AMEYALLI

MASTER PLAN AMENDMENT

APPLICANT'S PROPOSED AMENDMENTS

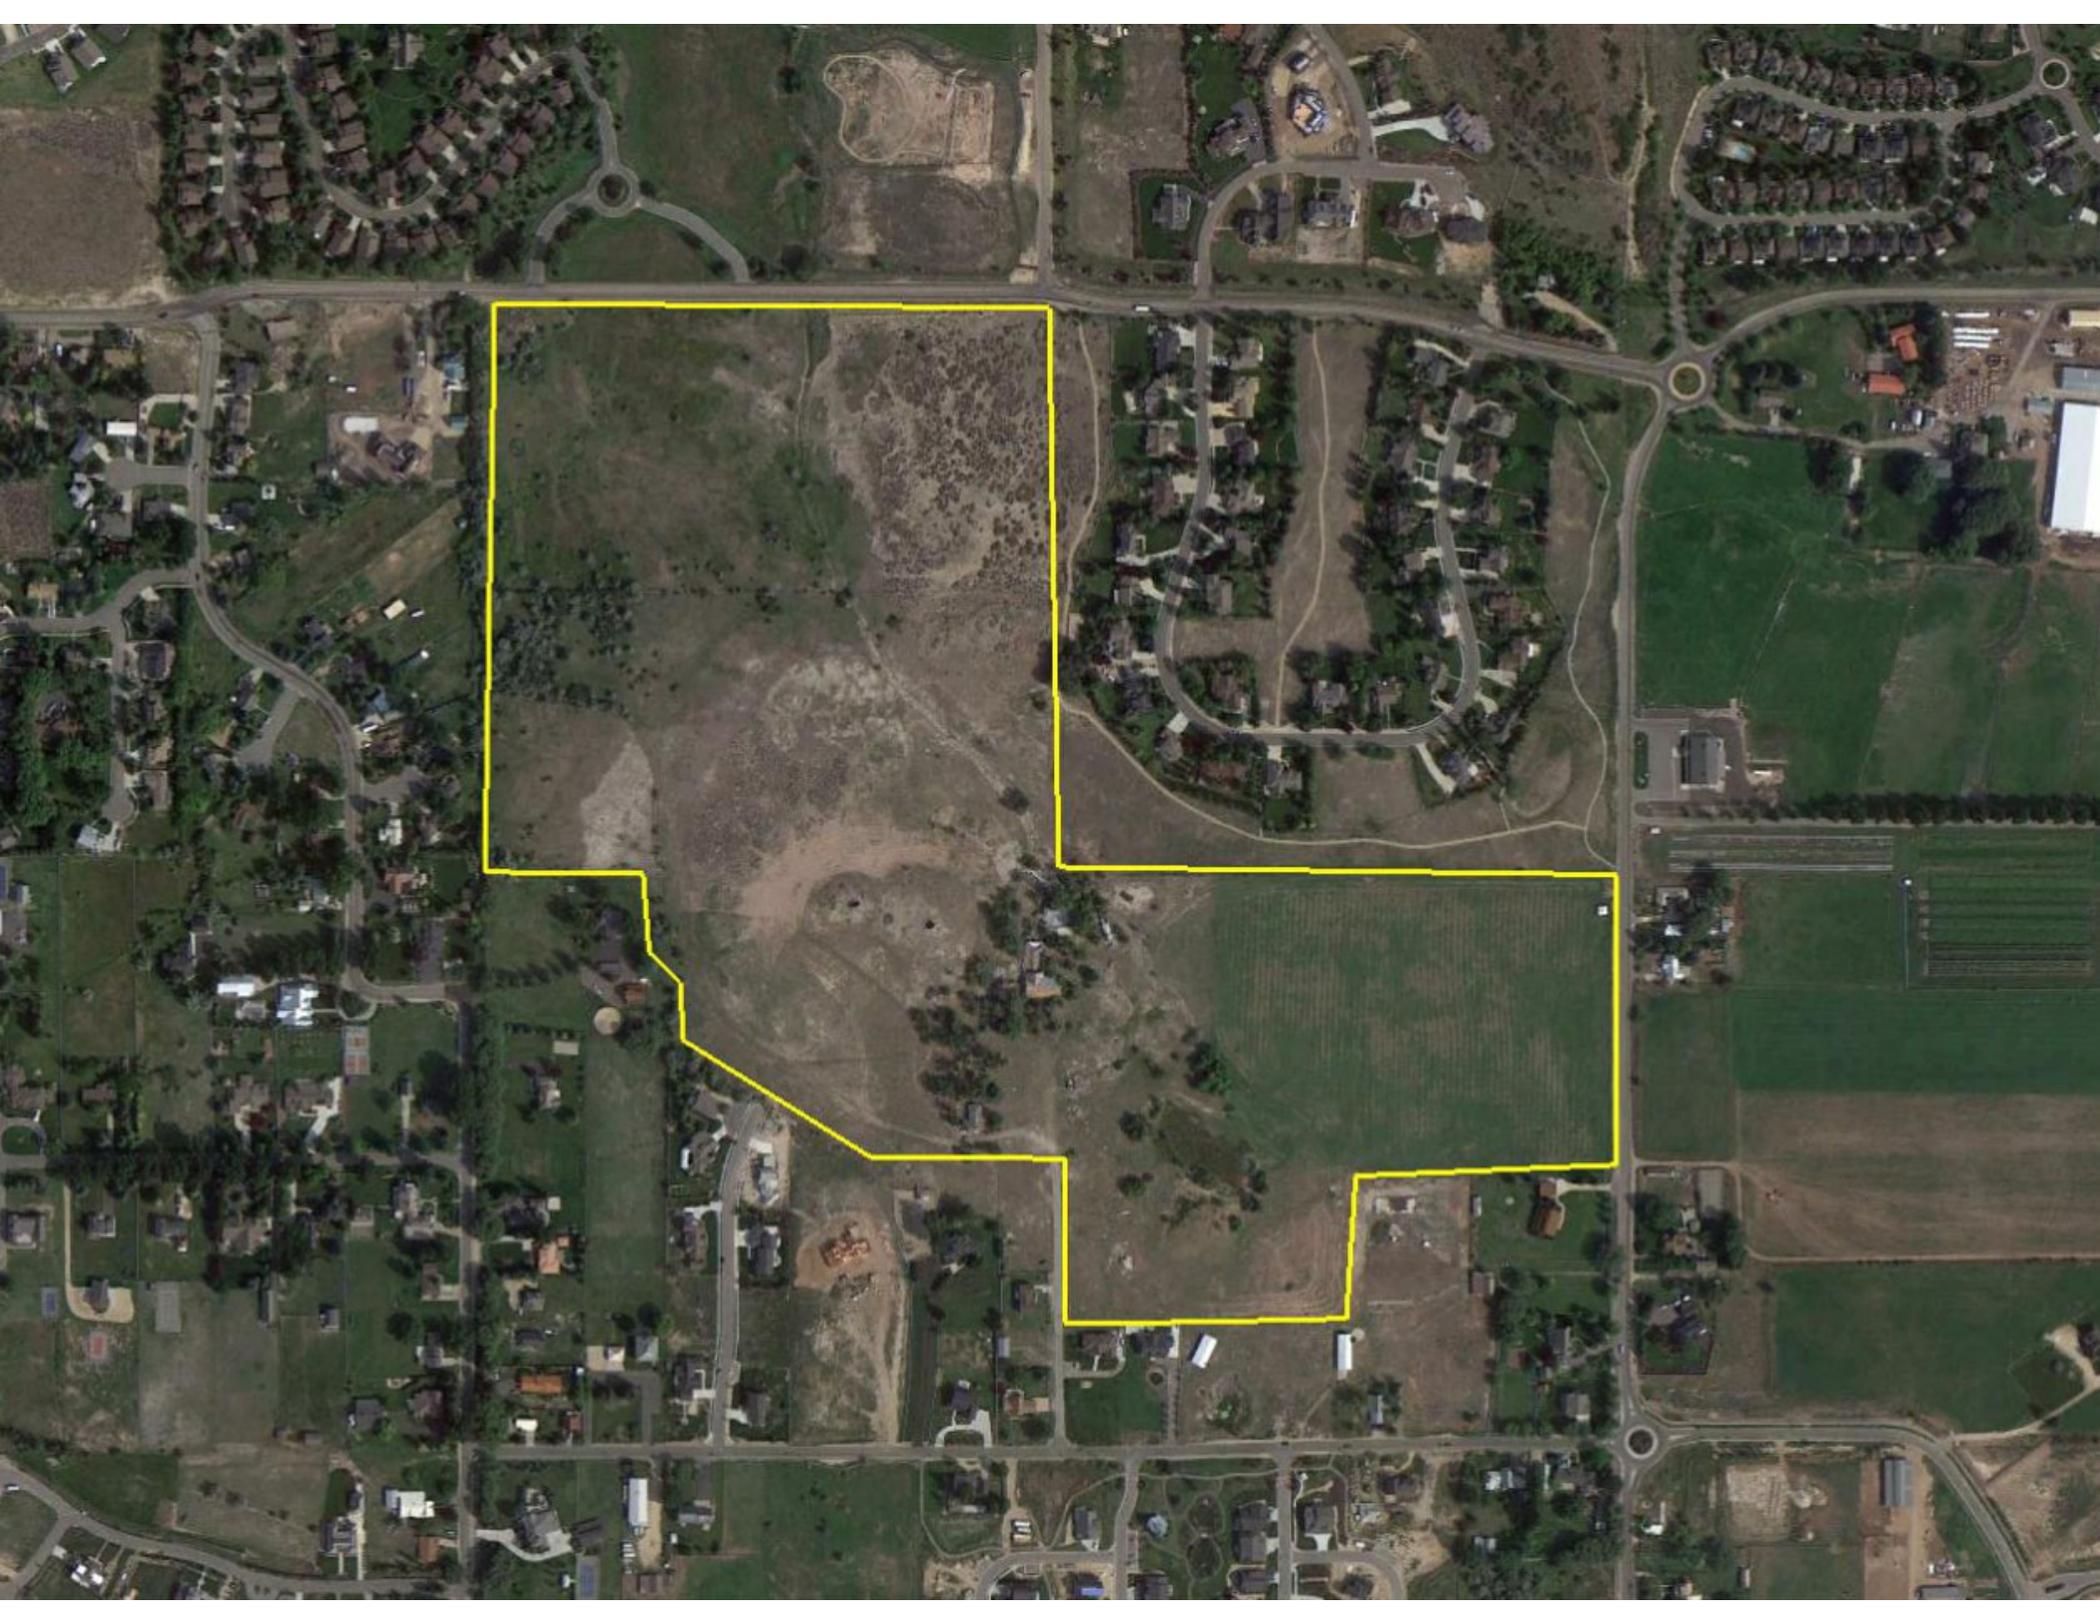
- Height Limit increased from 35' to 48' measured from natural grade (removed from application)
- Request to reduce the number of required parking stalls
- Reduce the number of phases from four to two
- Remove one of the inner private roads and replace it with a walking path

PHASE 2: AMEYALLI WELLBEING CENTER LEVEL 00

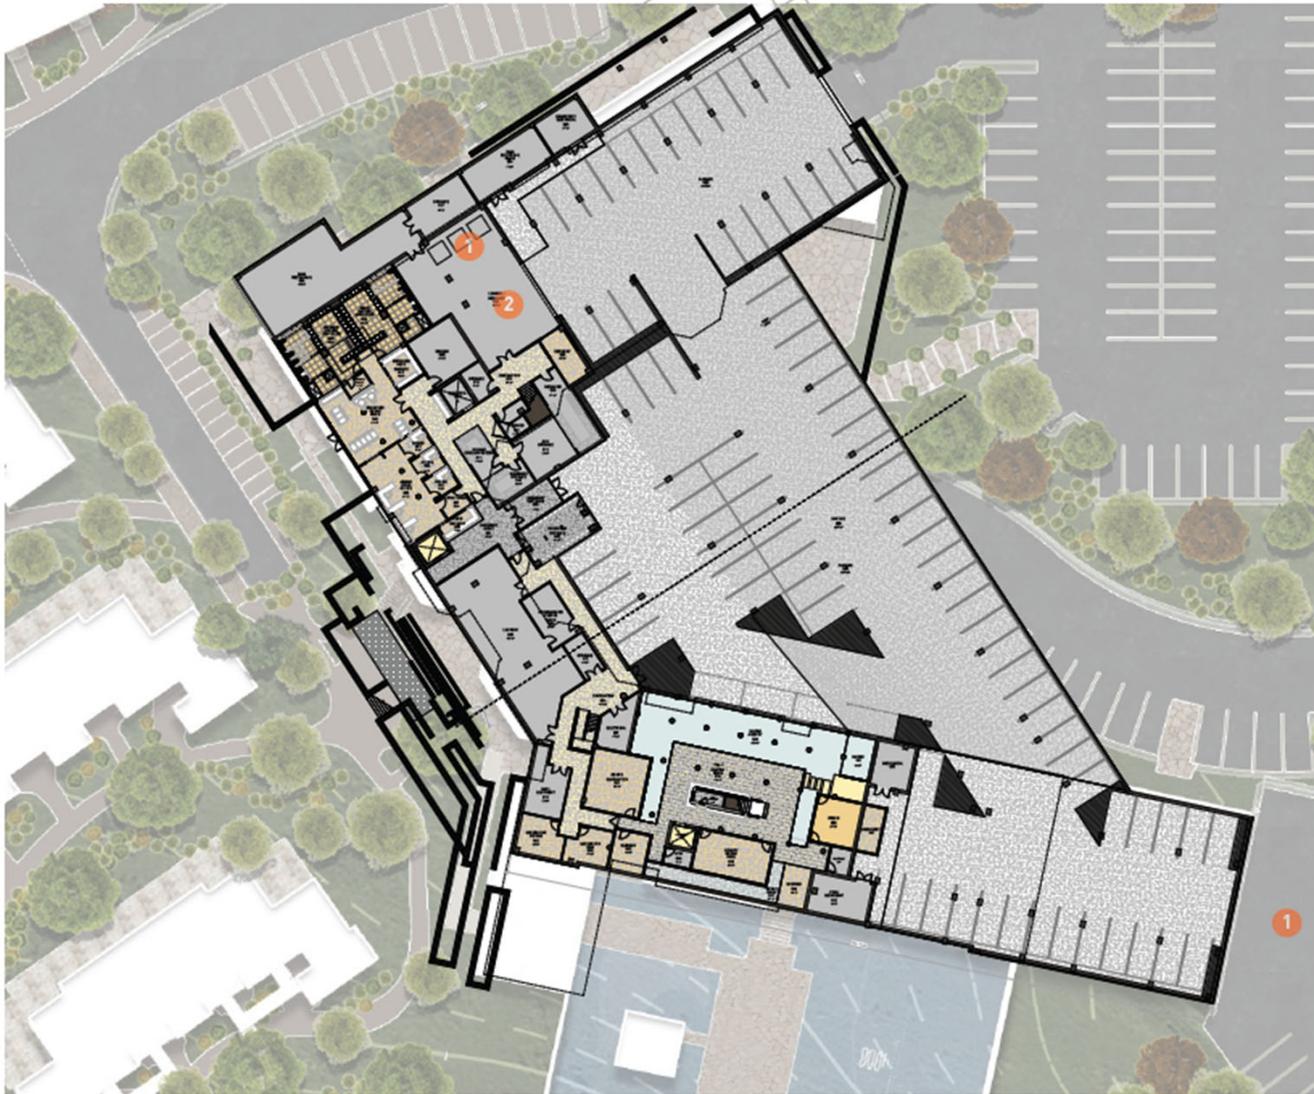
- Required parking is 302 stalls
- Applicant is proposing to reduce parking to 287 stalls
- Proposal is to reduce parking by 15 stalls
- Reduction proposal is based on the resort having vans on site: *“One 15 person resort owned passenger van is the equivalent of 5 cars or 5 parking spaces. Three vans are proposed for the resort.”*

- It is currently unknown if there will be enough parking for the resort, much like any business, it is recommended that a contingency plan is developed in case parking is not sufficient.
- Reducing phasing from four to two phases should not have negative consequences.
- The removal of the private road from phase four will comply with fire code requirements and will create better spacing for the area.

- The developer identifies future potential parking areas that will be developed if parking is determined to be an issue at the resort.
